UNITED STATES PATENT AND TRADEMARK OFFICE

Office Action Summary	Application No. 10/520,335	Applicant(s) KHAN, ANWA	
	Examiner MARK R. WENDELL	Art Unit 3635

DETAILED ACTION

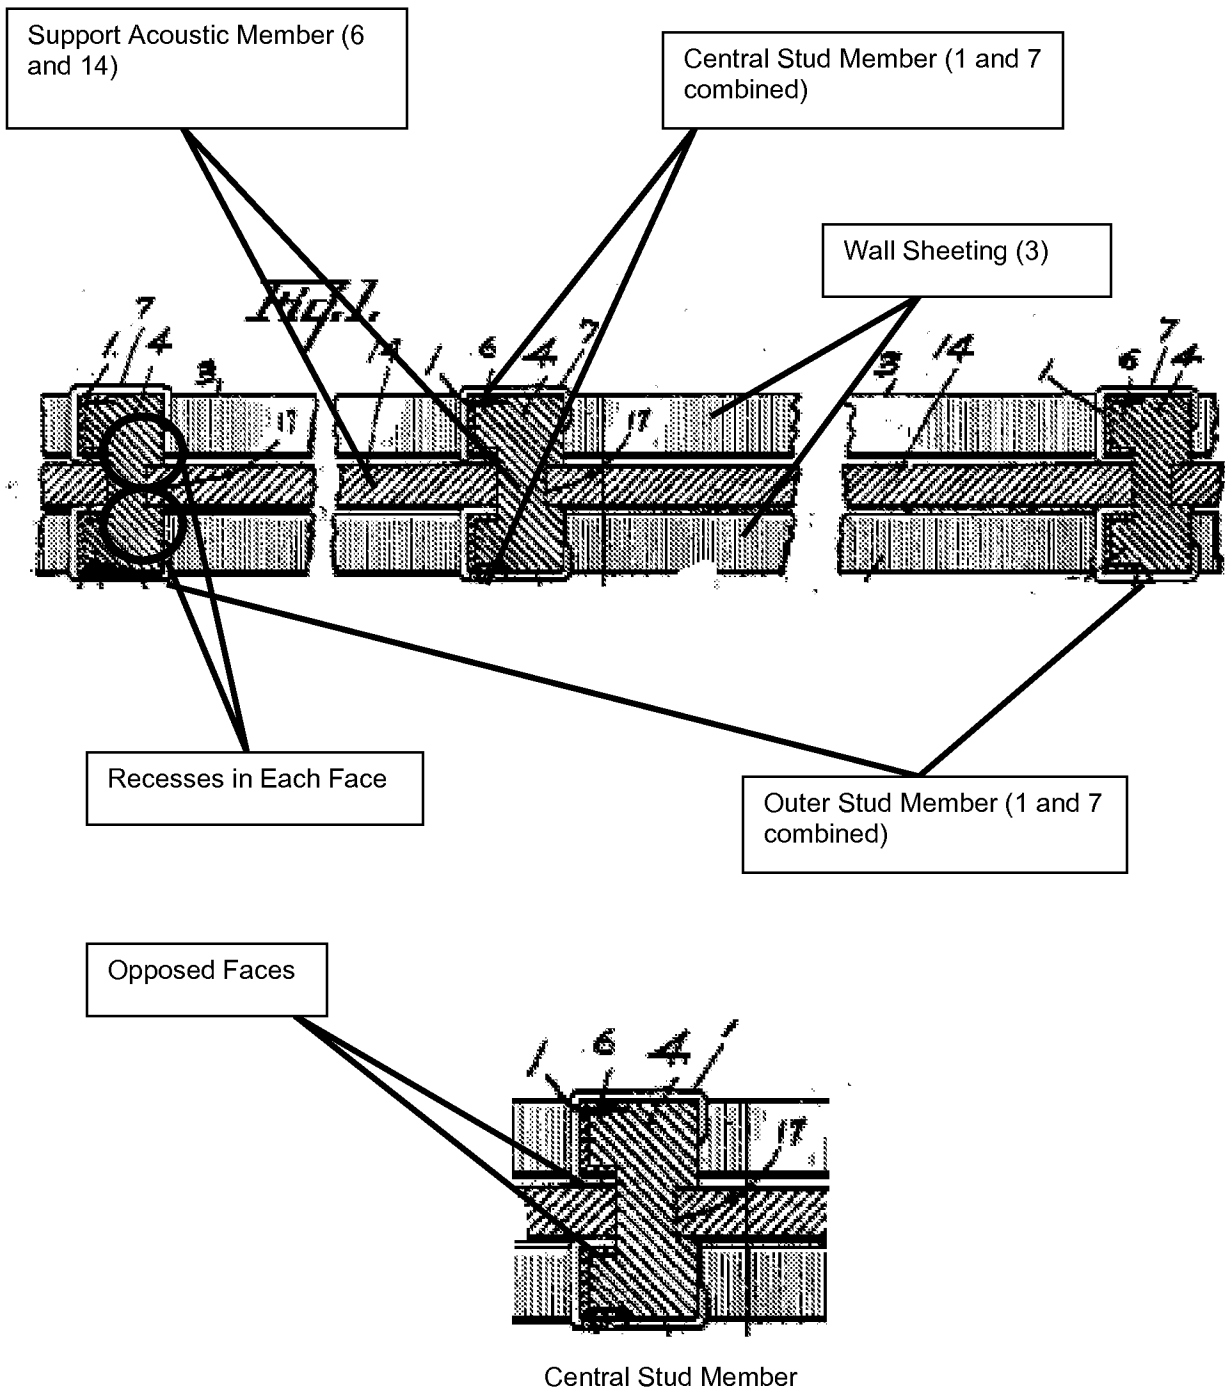
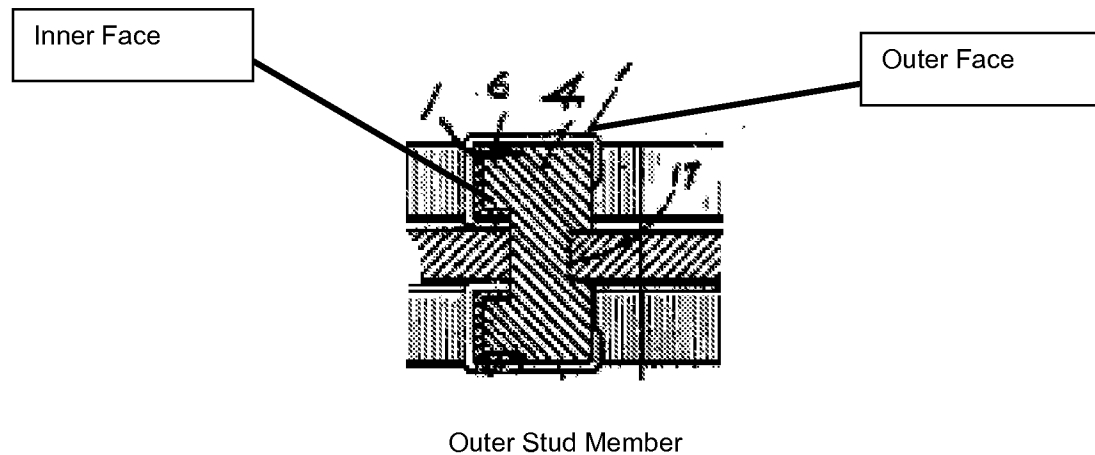
Claims 1-3 are rejected under 35 U.S.C. 103(a) as being unpatentable over Henderson (US 1841810) in view of Scott (US 5022211). Regarding claim 1, Henderson illustrates in Figure 1 and describes within the specification a stud for a wall structure comprising:

- At least one central stud member having opposed faces and a recess in each face (See Figure below);
- A support acoustic member mounted on each opposed face of the central stud member, each acoustic member being seated in and filling the recess formed in the face of the central stud (See Figure below);
- Outer stud members having an inner face and having an opposite outer face mounted on the outer side of each acoustic member and with the inner face being held captive thereby (See Figure below); and
- Wall sheeting connecting the outer faces of adjacent outer stud members (See Figure below).

Regarding claim 2, wherein each acoustic support member (6 and 14) has a major portion (6) having an inner face and outwardly extending spaced apart arms which terminate in inwardly directed flanges which define recesses. The examiner notes that the claim does not adequately define what the term “inwardly” means. It is not discernable to what the arms terminate inwardly with respect to. The acoustic member of the central stud has the arms terminating inwardly toward the outer stud members and the acoustic members of the outer stud members terminated inwardly towards the central stud member on one side and another outer stud member in the opposite direction.

Regarding claim 3, Henderson illustrates in Figure 1 the outer stud members having an enlarged head (14) that is located in the recess (of acoustic member 6) and held captive by the flanges (of acoustic member 6).

The examiner notes that the prior art and previous rejection meets the new limitations of the claims. Regarding claim 1, all of the wall sheeting is parallel to one another as can be seen in the illustrations above. Also, regarding claim 2 the new limitation that the flanges extend toward each other is met by the prior art. The thickness of the flanges inherently gives them the property of extending towards one another.
